Office Action Summary	Application No. 10/529,501	Applicant(s) ASTUDILLO LEY, RAFAEL	
	Examiner JENNIFER L. HORNBERGER	Art Unit 3734

DETAILED ACTION

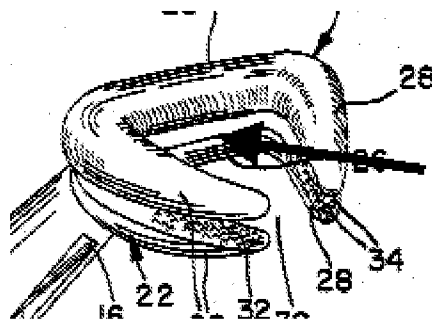
4. Claims 1-5 are rejected under 35 U.S.C. 103(a) as being unpatentable over Siegel (US 4,803,983) in view of Schuessler et al. (US 2,514,802).

Regarding claim 1, Siegel et al. disclose an artery holder for use in connection with heart surgery, characterized in that it comprises a gripping and fixing member including two mutually interacting first and second clamp elements (22,24) being arranged for gripping muscle tissue that encloses an artery in connection with a cut end of the artery, and for clamping muscle tissue while simultaneously fixing the artery and exposing said cut end. Siegel et al. fail to disclose a spring member being arranged to actuate the gripping and fixing member with a predetermined spring force in order to achieve said clamping of the muscle tissue, and an actuating member (11) being arranged to actuate the gripping and fixing member against the action of the spring force from the spring member (2) in order to open the clamp elements (3,9) for enabling

reception of muscle tissue therebetween and subsequent release of clamped muscle tissue. However, it would have been obvious to substitute the handle members (12, 14) and ratchet members (36,38) of Siegel et al. with the handle, spring, and actuating member (2, 10, 11) of Schuessler et al. because spring and actuating member design of Schuessler et al. offers the same function of constant clamping pressure without control by hand (col. 2, ln. 10-15). Substitution of one known element for another element providing the same function to yield predictable results would have been obvious to one of ordinary skill in the art at the time of the invention.

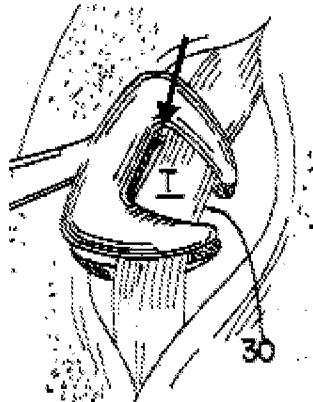
Regarding claim 2, Siegel et al. disclose an artery holder characterized in that the first clamp element (22), being intended to be located closest to the cut artery end, has a central recess (15) at its end edge, said recess being open forwards and being defined by two tongues (28) projecting forwards, and being arranged for receiving a portion of the artery when inclining the artery holder in relation to the artery, whereas the second clamp element has a straight end edge (see straight end edge designated by the arrow in the figure below) arranged for supporting against the artery during said inclining of the artery holder.

Regarding claim 3, Siegel et al. disclose that the said recess (15) is V-shaped (see V-shape designated by the arrow in the figure below).
